SERVICE BULLETIN

EL14-009

2008 – 2014 ROGUE; MAIN HARNESS TO BODY HARNESS ELECTRICAL CONNECTOR CORROSION

APPLIED VEHICLES: 2008 – 2013 Rogue (S35)
2014 Rogue Select (S35)

Figure 1

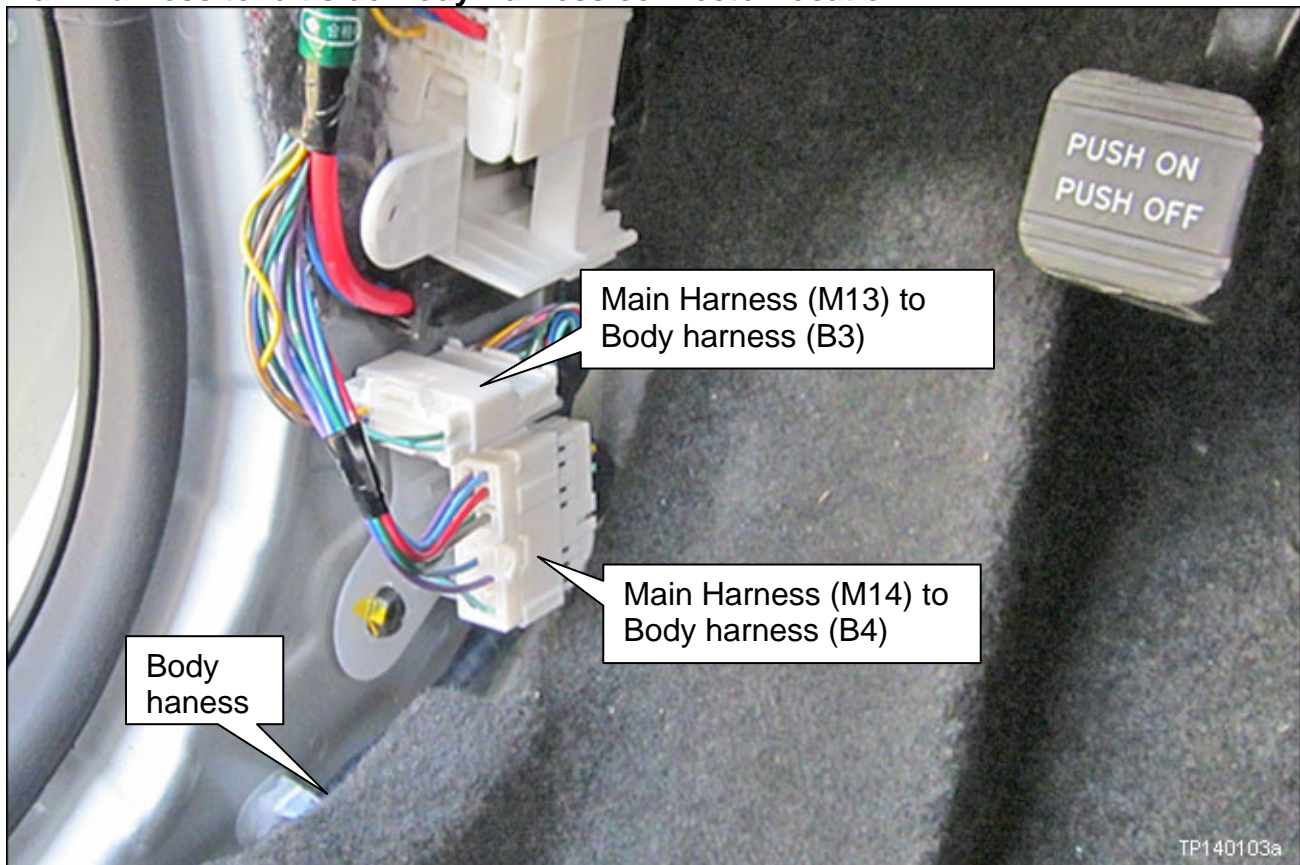
An electrical issue caused by corrosion in the Main Harness to Body Harness connectors located at the bottom of the driver side A-pillar.

- Connector numbers M13 to B3 and/or M14 to B4.

- Examples of electrical issues that may occur are; power seat inoperative, power windows inoperative, radio inoperative, horn sounds on its own, etc.
- See Figure 1 on page 2 for connector location.

1. Perform repairs to harness connectors as needed.
2. Apply "Harness Protector" to cover the harness connectors.

1. Inspect connectors M13, M14, B3, and B4.
2. Perform repair to the connectors as needed.
 - Use harness repair kit J-48817 as needed to perform repairs.
NOTE: For instructions on using harness repair kit J-48817, refer to **ASIST >> Tech-Mate >> Tech-Mate Tools & Equipment >> Harness Repair Kit User Guide.**
 - If necessary, replace the Main Harness and/or Body Harness:
NOTE: If needed, refer to the Electronic Service Manual (ESM) for harness replacement information.
 - During harness repair, cover connectors M13/B3 and M14/B4 with harness protector (see Figure 2 on the next page).
